# SERVICE BULLETIN

## INSPECTION OR REPLACEMENT OF THE ROCKER ARMS AND VALVE PUSH-RODS FOR ROTAX® ENGINE TYPE 912 AND 914 (SERIES)

SB-912-035 R1

SB-914-021 R1

**fig. 4** **Detail X**

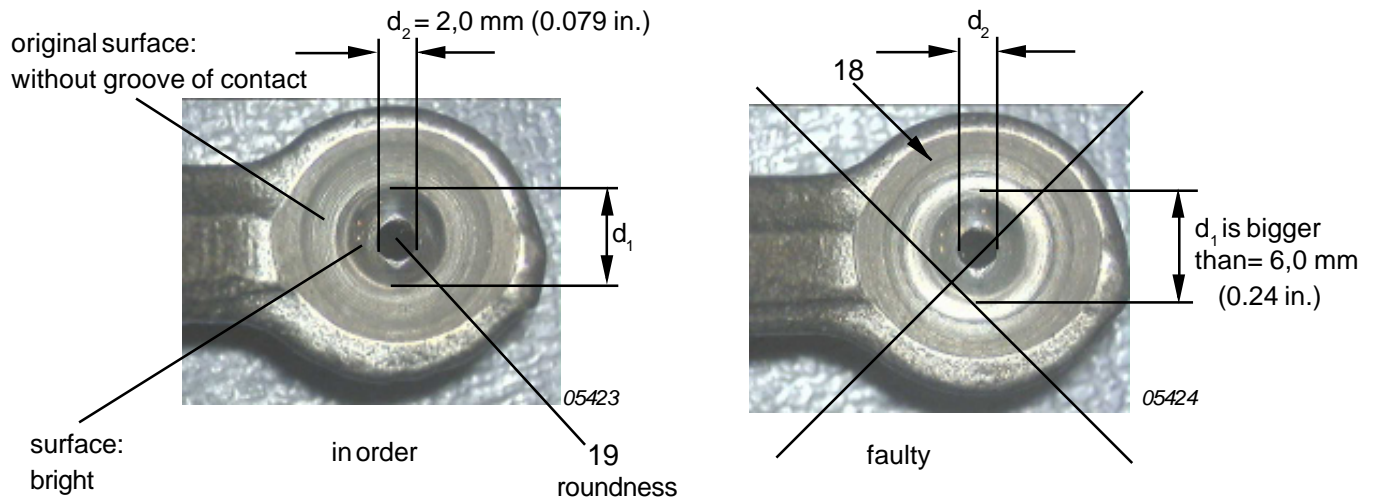
◆ **NOTE:** Detailed visual inspection particularly in the rocker arm ball joint (female) area.  
See fig. 4.

- Inspect rocker arm ball joint (female) (18). Traces of wear on the rocker arms are noticeable by geometric changes of the spherical form and smoothed areas in the ball joint shine brightly. Should the engine not have been running for more than one month, then the shining part may become dull again. The diameter of the smoothed running surface, measured by a sliding caliper (or equivalent) along the rocker arm axis, shall not exceed a value of  $d_1=6,0$  mm (0.24 in.). Inspect lubricating bore (19)  $d_2= 2,0$  mm (0.079 in.) for roundness. The roundness tolerance must lie within 0,2 mm (0.0079 in.). Any tendency towards an oblong hole is not permissible.

- Should one of these criteria be encountered, replace the appropriate rocker arm **and** its associated push-rod.

**fig. 3**  
05122

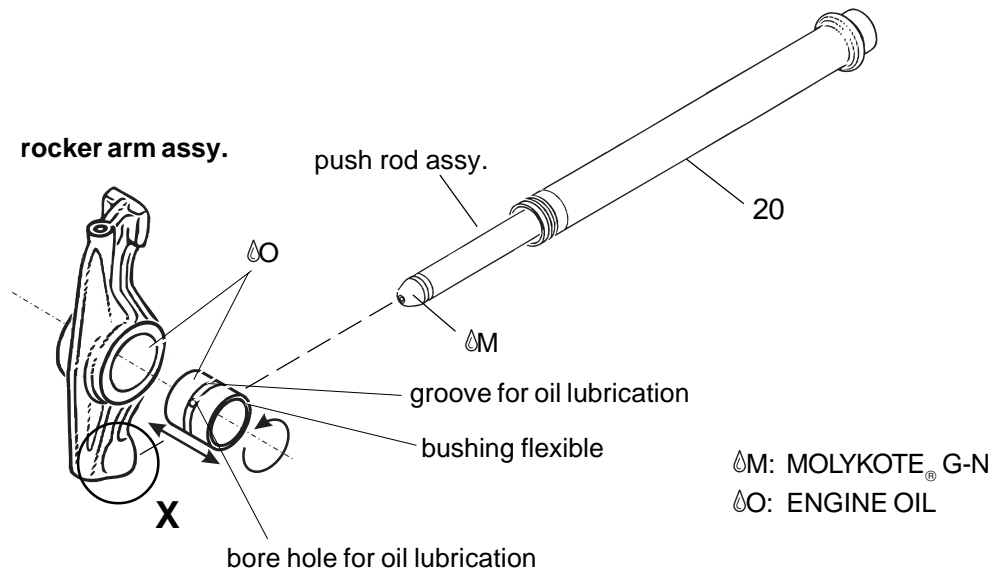
- Visually inspect all rocker arms and push-rods for damage or wear and tear. You may reuse the parts, provided that the accomplishment of the instructions of rocker arms and push-rod did not substantiate damages or traces of wear.

- Inspect both push-rod ball joints (male) for imperfections. Inspect it with a magnifying glass and carry out a fingernail test on the push-rod ball joints. To perform the fingernail test, move the fingernail gently over the ball joints. If any noticeable grooves are detected, parts are not any more reusable.
